**City of Bellevue  
Development Services Department  
Land Use Division Staff Report**

PROPOSAL NAME: **Bellevue Tower**

FILE NUMBER: **07-132105-LD**

**Director's Decision: Approval with Conditions**

PROPOSED BUILDING SETBACKS  
(from City required curb locations)

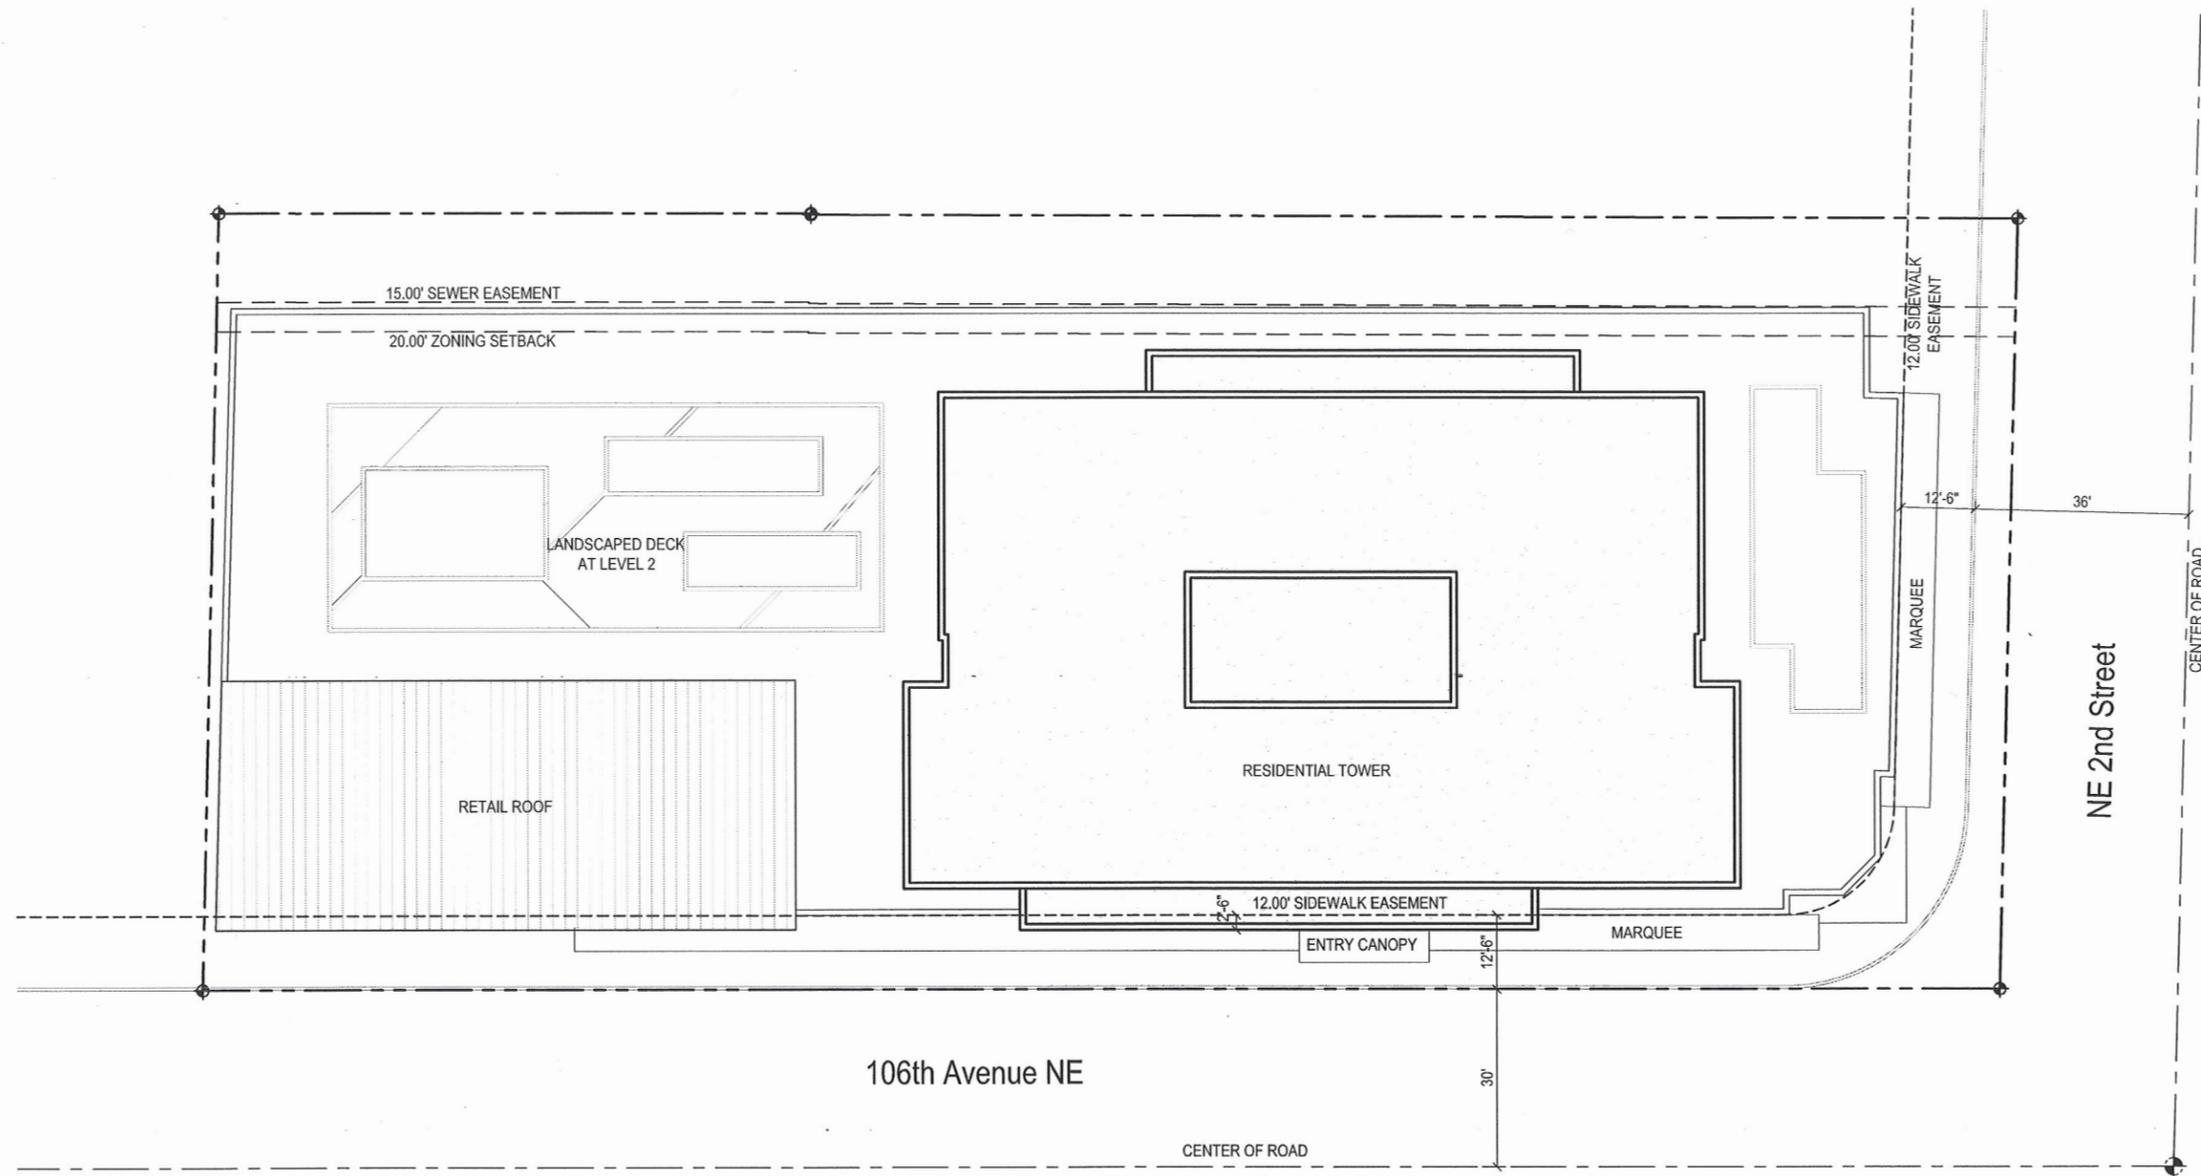
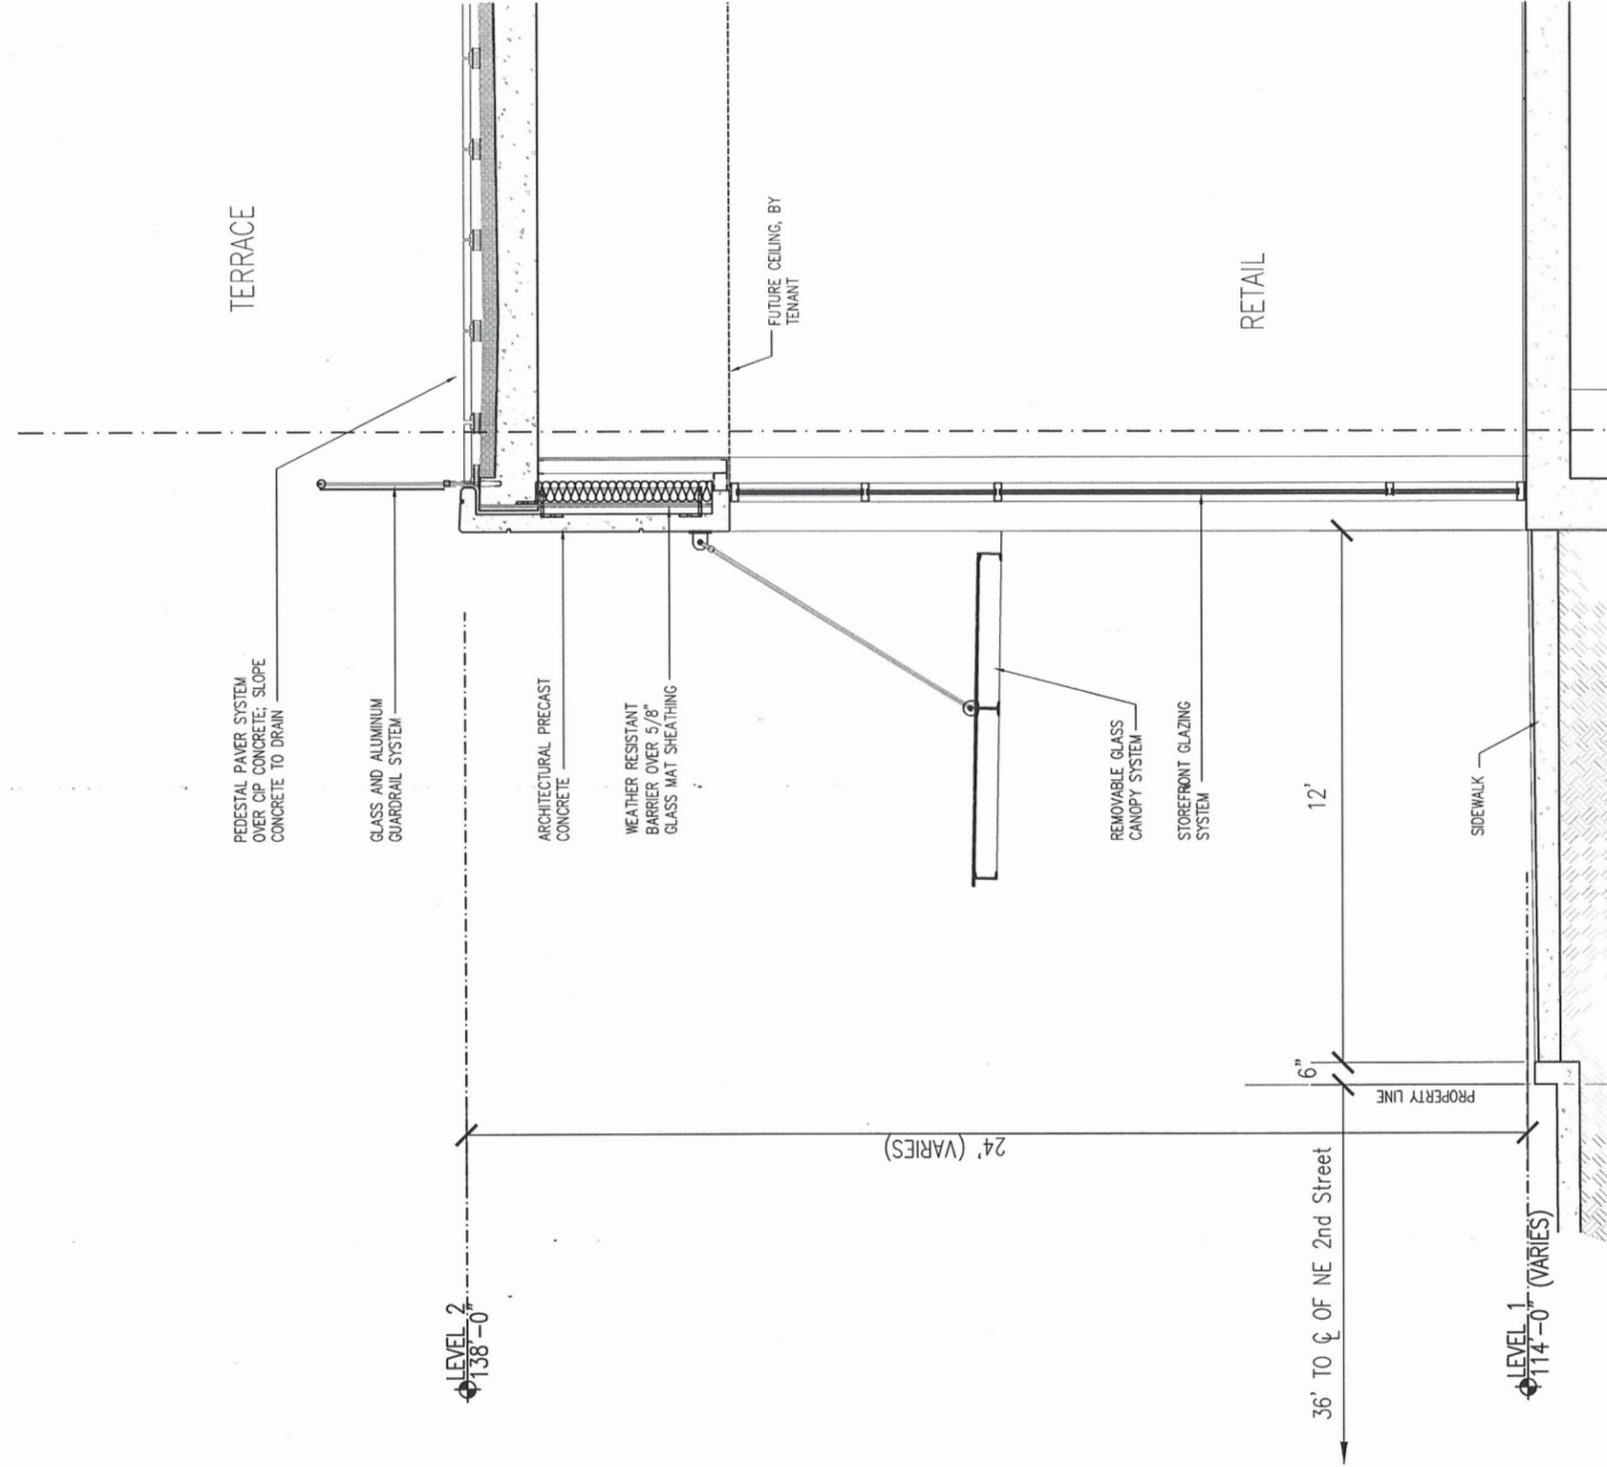
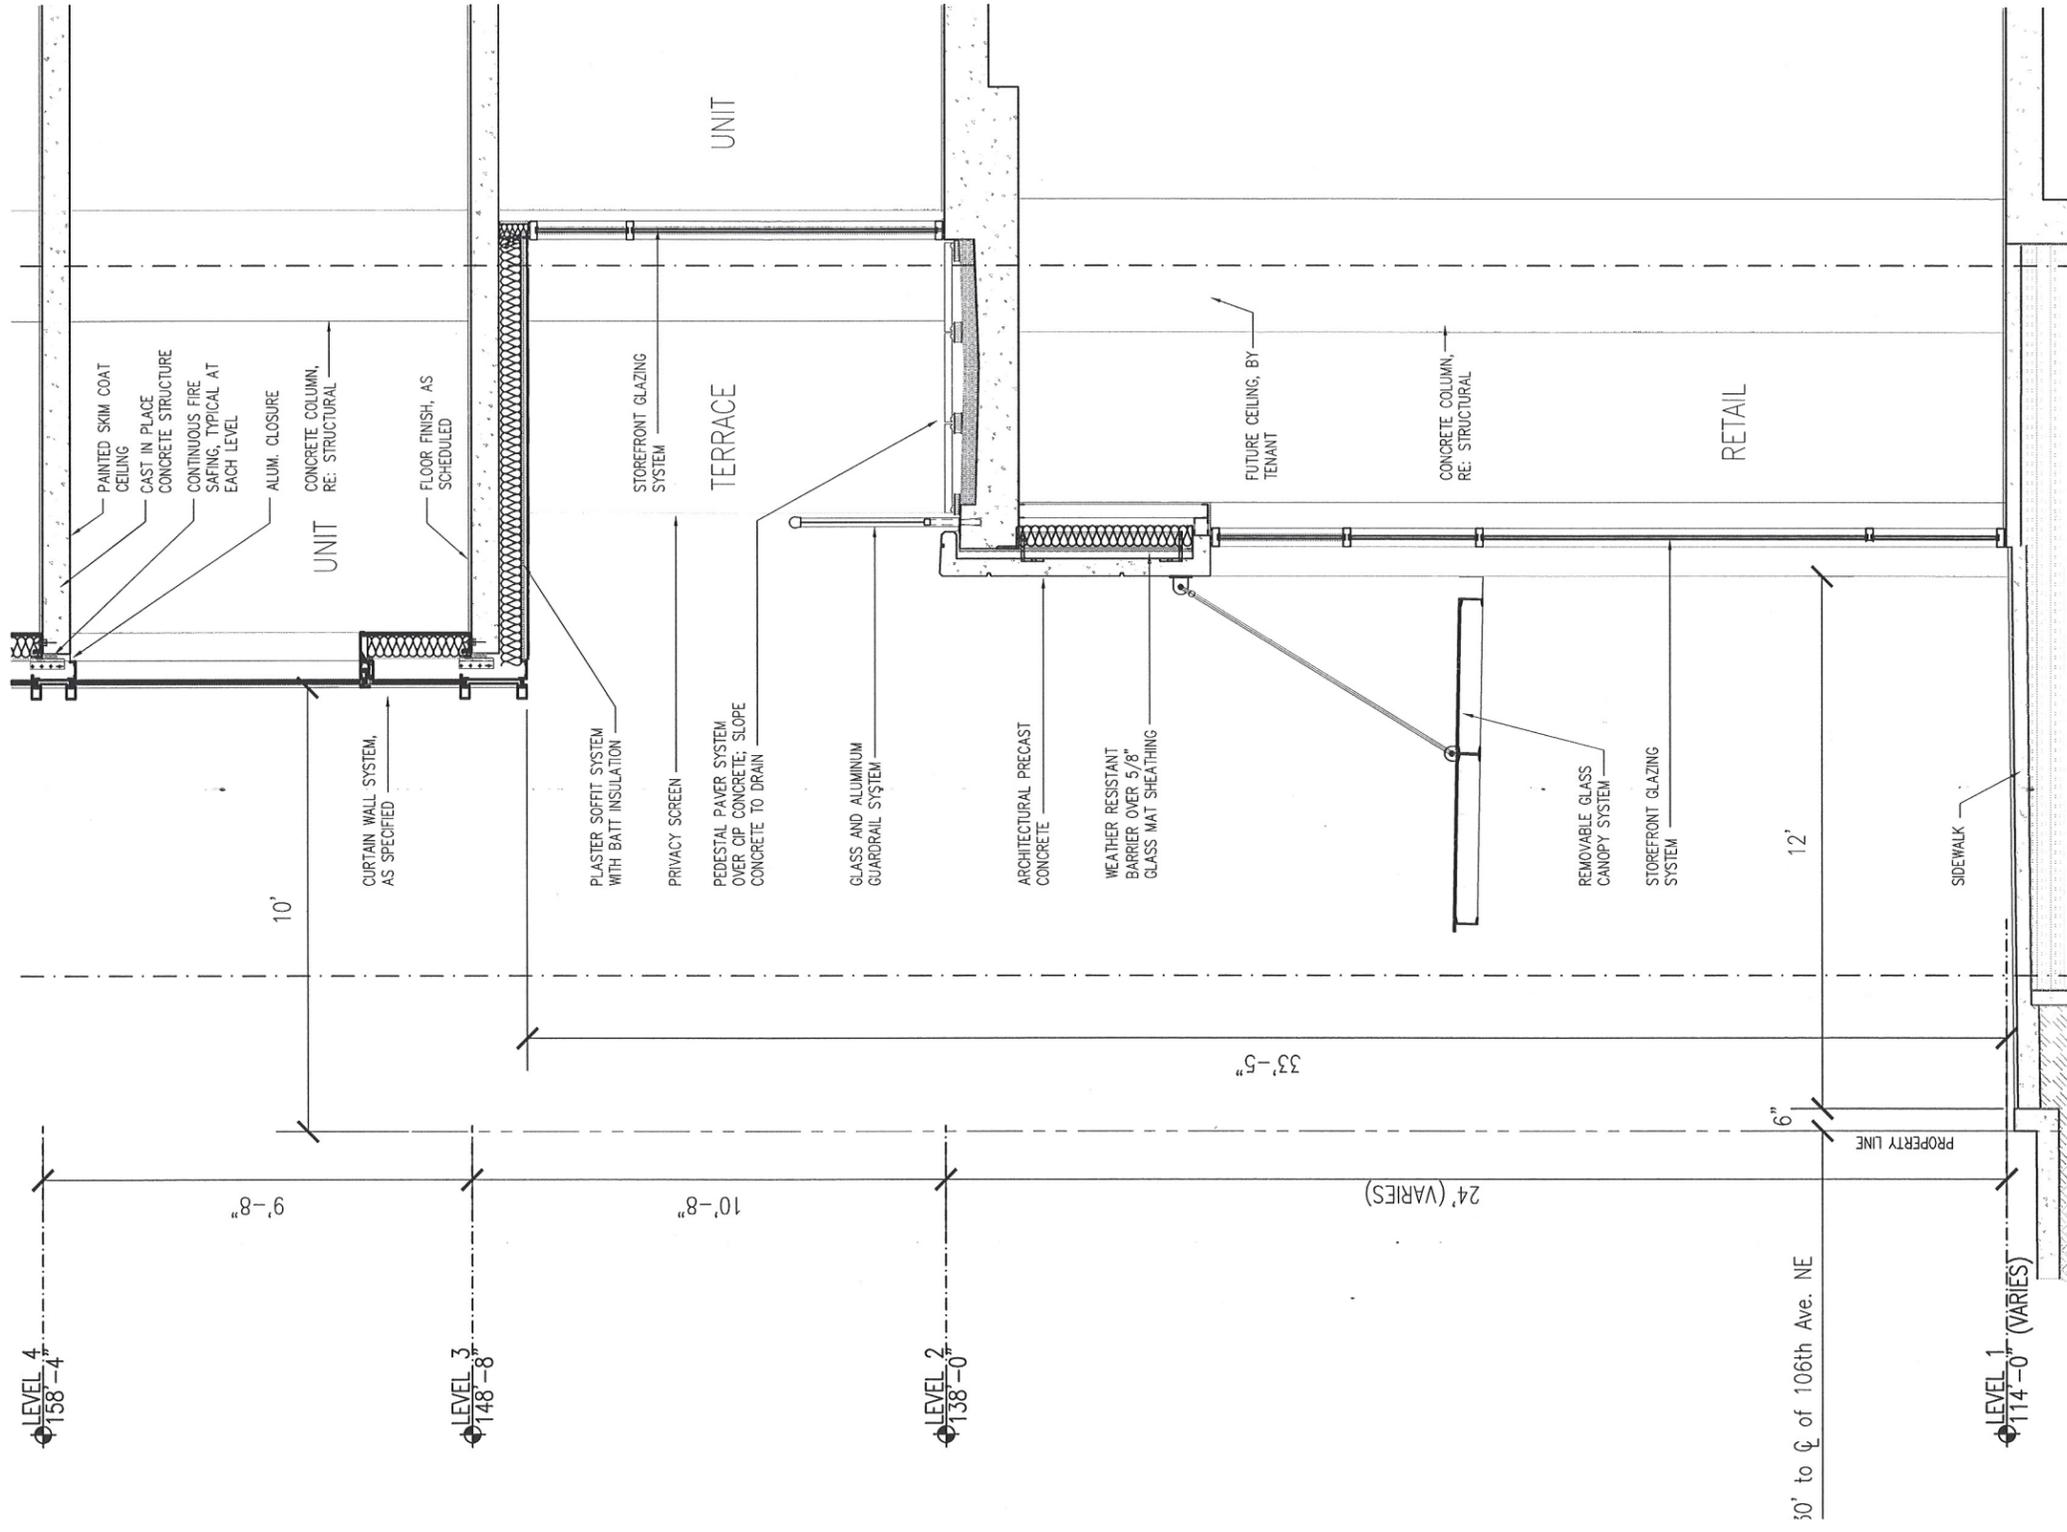
The required distances from the center line to back-of-curb for each roadway abutting the site are 30'-6" for 106th Ave. NE, and 36'-6" for NE 2nd St. The proposed and required widths for the roadway/sidewalk along each frontage are illustrated in Attachment B. The applicant has agreed to submit Building Permit plans which correctly locate these elements, and to revise the structure design as necessary without making fundamental to the overall concept for the parking, podium and tower (Attachment F)
